RE: ENGINEER'S CERTIFICATION FOR BLACK-EYED PEA RESTAURANT
(K-21/D20A) CERTIFICATION STATEMENT DATED NOVEMBER 26, 1991

RE: REVISED DRAINAGE PLAN FOR BLACK-EYED PEA RESTAURANT (K-21/D20A)
ENGINEER'S STAMP DATED JULY 30, 1991, RECEIVED JULY 30, 1991

RE: REVISED DRAINAGE PLAN FOR BLACK-EYED PEA RESTAURANT
(K-21/D20A) RECEIVED JULY 15, 1991

RE: DRAINAGE PLAN FOR BLACK-EYED PEA RESTAURANT
(K-21/D20A) RECEIVED JUNE 20, 1991

PIPE CULVERT ANALYSIS:

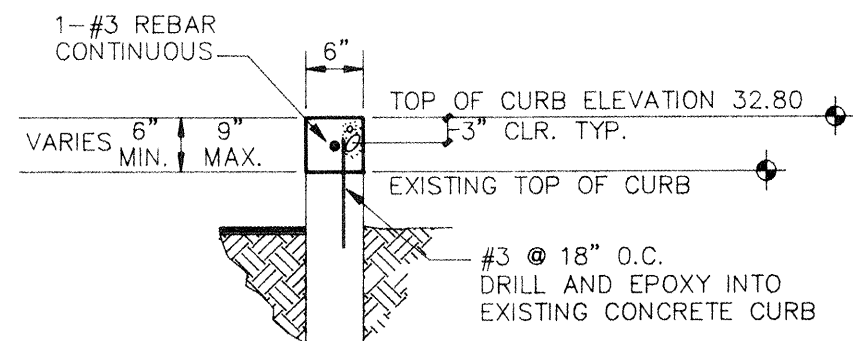
1. Your calculations for determining the capacity of the existing 2 - 24" cmfs does not take into account inlet and outlet control. You may want to use culvert design aids by the U.S. Bureau of Public Roads Culvert Capacity Charts to determine your true capacity.
2. Your calculation for the depressed curb 4' wide will need to be treated as a weir.

Assumptions:
Each pipe to flow 15 cfs of runoff
2 feet of tail water (worst case)

Results:
Headwater outlet controlled 2.74'

Existing conditions:
Headwall height 2.65'

Limits of 100 year storm:
Elevation 5532.26

HEADER WALL EXTENSION DETAIL

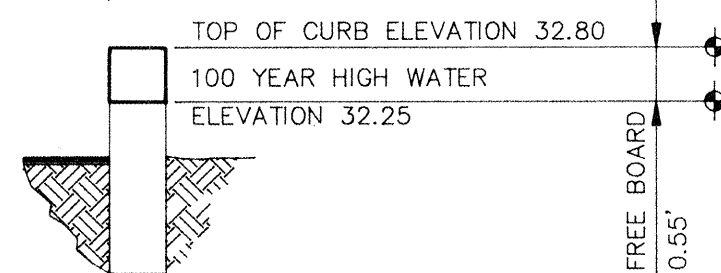
1. ✓ Key note #1 must be changed to reflect the weir width.
2. ✓ Remove or cross through the calculations pertaining to the culverts and curb cuts.
3. ✓ You may want to recompute your intensity.
 $I = (6 \text{ hr rainfall}) 6.84(10)^{-.51}$ it will probably give you a smaller answer.
4. ✓ How did you determine your pipe culvert capacity? Did you use the charts?
5. ✓ Please identify that the perimeter wall top elevation will be higher than the 100 year water surface.

INSTALL "HEADER WALL EXTENSION" TO ALL EXISTING CONCRETE CURB BELOW ELEVATION 32.80 AS SHOWN ON THE GRADING AND DRAINAGE PLAN.
